# False Detection Problem

Steve Robbins

# Circuit Theory

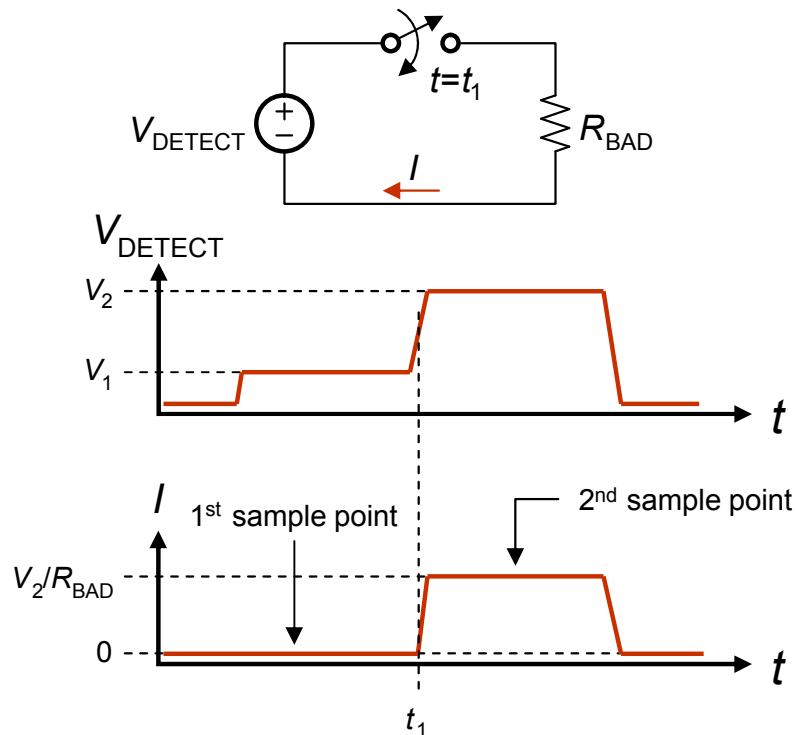
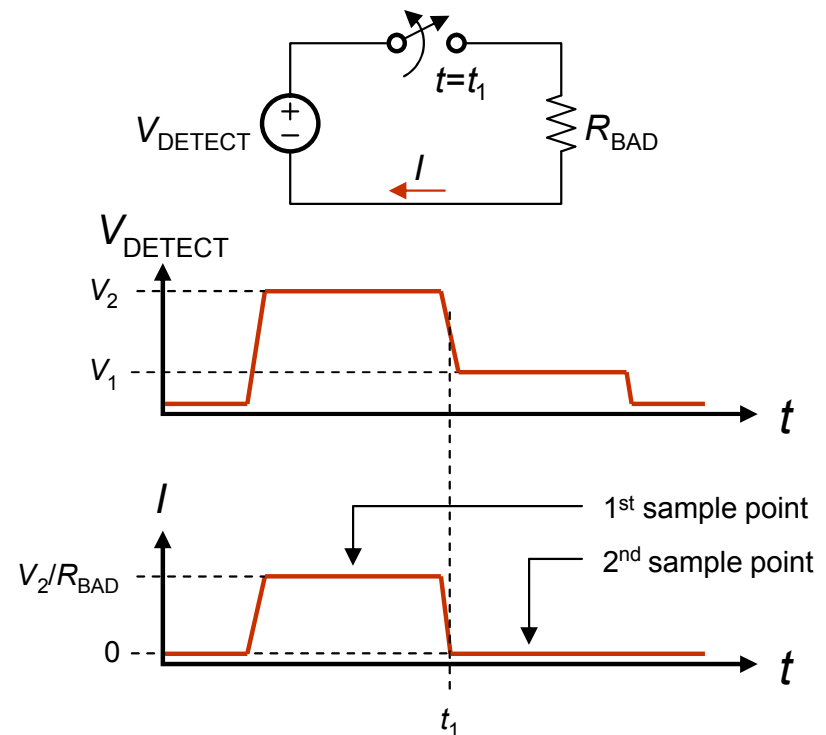
**Case 1:** Invalid PD connected in the middle of detection

**Case 2:** Invalid PD disconnected in the middle of detection

**Note:** Two other cases are possible, where the open circuit occurs while  $V_{\text{DETECT}} = V_2$ . But these cases produce a negative number for  $R_{\text{MEASURED}}$ . The PSE controller should be designed to ignore negative detection signatures.

- In both the cases from the previous slide, the PSE sees

$$R_{\text{MEASURED}} = \frac{V_2 - V_1}{V_2/R_{\text{BAD}} - 0} = R_{\text{BAD}}(1 - V_1/V_2)$$

- Plugging in some typical numbers from 802.3af Table 33-2
  - A typical  $R_{\text{GOOD}}$  range: 16.5k to 30k.
  - Some typical voltage levels:  $V_1=3\text{V}$  and  $V_2=6\text{V}$ .
  - Result: Invalid signatures from 33k to 60k can fool the PSE.
- Worst-case
  - Extreme limits of  $R_{\text{GOOD}}$  range: 15k to 33k.
  - Extreme voltage limits:  $V_1=9\text{V}$  and  $V_2=10\text{V}$ .
  - Result: Invalid signatures from 150k to 330k can fool the PSE.

- Change the PSE state diagram to require two consecutive successful detection cycles before it turns on power to the PD.
- The timing requirements of 802.3af Table 33-5 can stay as they are:
  - Detection time ( $T_{det}$ ) is 500ms maximum.
  - Midspan backoff time ( $T_{dbo}$ ) is 2 seconds minimum.
  - Therefore an endspan PSE is guaranteed enough time for at least 4 detection cycles.
